Access Compliance Report Public Rights-of-Way (Curb Ramps)

Main Street: BOW_PL Cross Street: CRANBROOK_DR Location: NE

ADA ID: RPAT211022151934 Ramp Type: Type 1 - Perpendicular Diagonal Initial Pass/Fail: Pass Overall Compliance: No Severity Score: 20

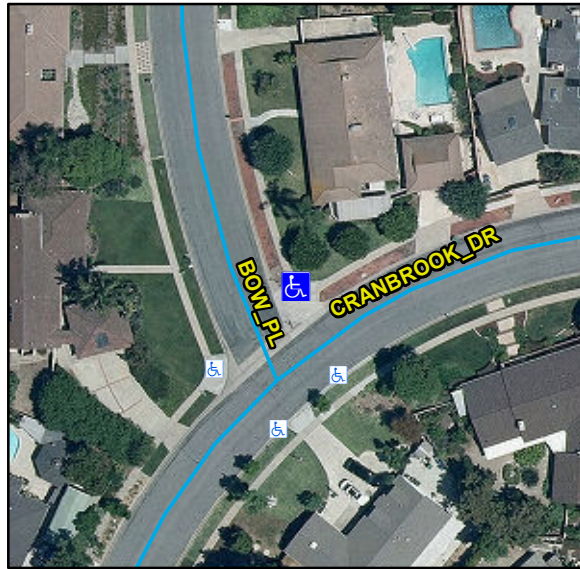
R304.2.2, R204.3, R304.2.1, R304.2.2-Perp, R304.3.2-Para, R304.5.3, R305, STD 1115

Compliance	Description	Data	Compliance	Description	Data
N/A	Ramp Length (in)	128	N/A	Flare Type LT	
Yes	Ramp Width (in)	58			Sloped
Yes	Ramp Run Slope (%)	6.2	N/A	Flare Slope LT (%)	4.8
Yes	Ramp Cross Slope (%)	1.2	N/A	Flare Traversable LT	No
N/A	Landing Present	No	N/A	Flare Type RT	
N/A	Landing Length (in)	N/A			Sloped
No	Landing Width (in)	N/A	N/A	Flare Slope RT (%)	3.4
No	Landing Run Slope (%)	N/A	N/A	Flare Traversable RT	No
No	Landing Cross Slope (%)	N/A	No	DWS Provided	No
N/A	Landing Movement Obstructed?	No	N/A	DWS Contrast	N/A
	Landing Movement Type	N/A	N/A	DWS Length (in)	N/A
N/A	Landing Shared	N/A	N/A	DWS Full Width	N/A
N/A	Clear Space	Yes	N/A	DWS Offset Left (in)	N/A
N/A	Clear Space To Crosswalk (in)	48	N/A	DWS Offset Right (in)	N/A
N/A	Marked Crosswalk 1	No	N/A	Marked Crosswalk 2	No
	Crossing 1 Direction	W		Crossing 2 Direction	S
	Marked Crosswalk 1 Width (in)	N/A		Marked Crosswalk 2 Width (in)	N/A

N/A	Ramp Inside Crosswalk 1	N/A	Yes	Ramp Inside Crosswalk 2	N/A
	Crossing 1 Slope (%)	4		Crossing 2 Slope (%)	4.8
	Crossing 1 Cross Slope (%)	0.7		Crossing 2 Cross Slope (%)	0.6
Yes	Gutter Ponding	No	No	Curb Slope	8.4
Yes	Gutter Lip Height (in)	0		Road Run Slope (%)	1.4
Yes	Gutter Run Slope (%)	2		Road Cross Slope (%)	2.1
Yes	Gutter Cross Slope (%)	0.7			
Yes	Overall Surface Condition: Acceptable		No	Perp Joint Present	No
	Cross Gutter Present?	Yes		Spandrel Present?	Yes
	Replace Cross Gutter?	No		Replace Spandrel?	No

Remove & Replace Curb Ramp With Two New Directional Ramps or Equivalent.
